CTEW1022BP-WHT

SUBMITTAL IDENTIFICATION SHEET

WEBSTER UNIVERSITY ISB
PROJECT NAME

123553-001 REV 2
CONTRACTOR / CM SUBMITTAL NO.

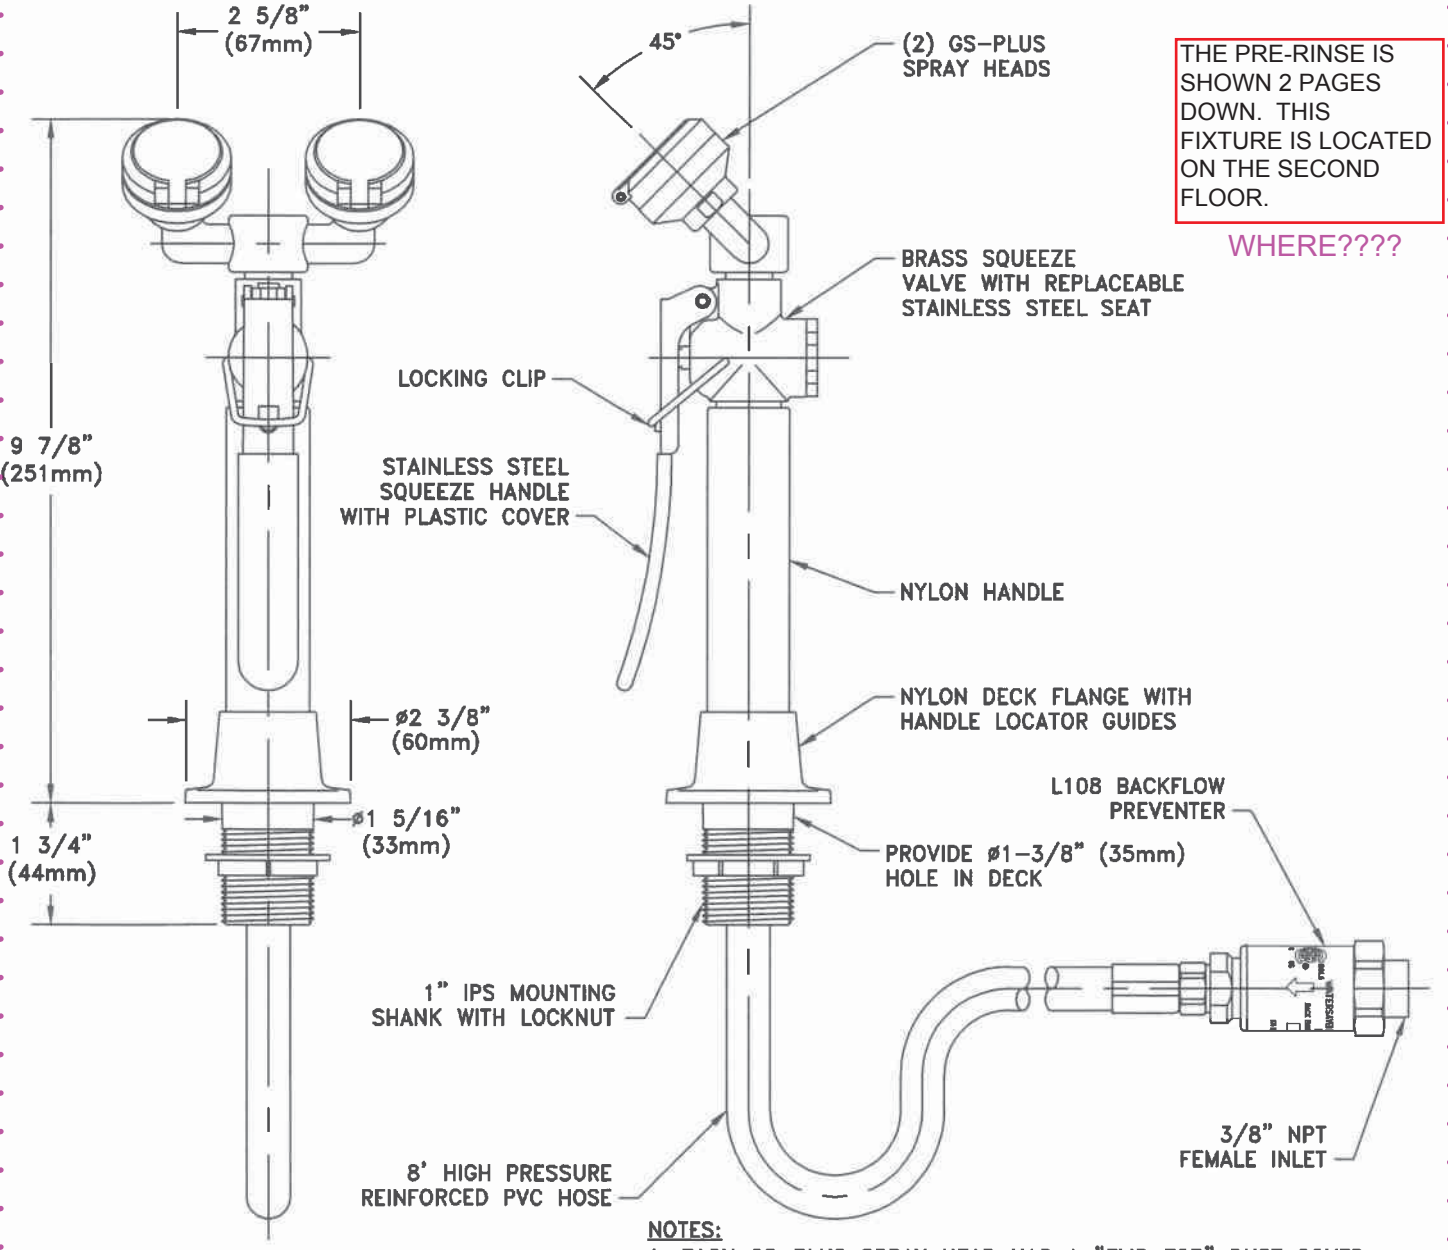
FIXTURE APPROVAL ON HOLD
- PLEASE CALL TO DISCUSS

THE PRE-RINSE IS SHOWN 2 PAGES DOWN. THIS FIXTURE IS LOCATED ON THE SECOND FLOOR.

WHERE????
